Appendix 5.6a: 2019 King Street Station ADA Assessment Report

2019 King Street Station ADA Assessment Report

Date Assessment Completed: 9/6/2019

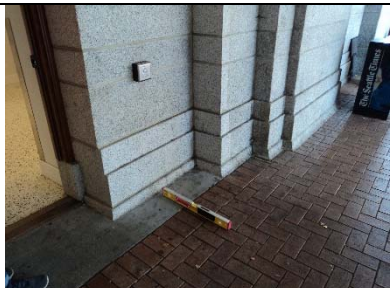
#	Location	Observed Condition	ADA Requirement
2.3.6	Lower level passenger loading zone area (second area from the south approach from King Street, PLZ2).	The access aisle does not adjoin an accessible route. The vertical level change between the access aisle and the concrete is greater than ¼” at 3/8”. <i>Note: this may be considered within a reasonable construction tolerance for existing conditions.</i>	503.3 Access Aisle. Passenger loading zones shall provide access aisles complying with 503 adjacent to the vehicle pull-up space. Access aisles shall adjoin an accessible route and shall not overlap the vehicular way.
	Photograph(s):		
	Recommended Action:	Apply asphalt or pavement to match elevation between the two surfaces.	
	Additional Comments:	Alternatively, locate the accessible passenger loading zone at one of the other available areas.

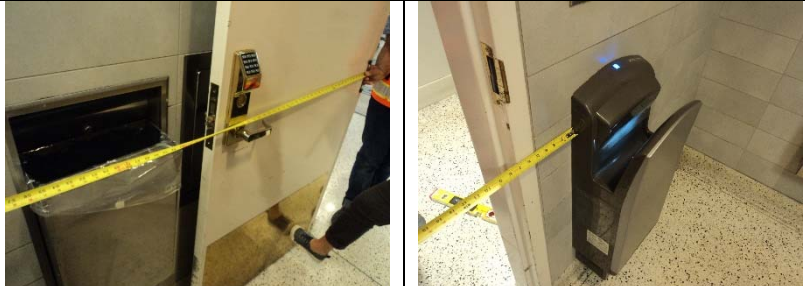
Note: In the main lobby / passenger concourse, there are multi-user women’s and men’s toilet rooms and a family toilet room. All contain accessible features. In the Arts area on the upper level, clustered unisex toilet stalls are provided with a communal sink. Two of the toilet stalls are identified as accessible (3111A, 3111D), with one being locked for employee use (3111D). In addition, a single-user accessible toilet room is provided in this area (3111B). Addressing all the issues identified in this section exceed what is required under the ADA.
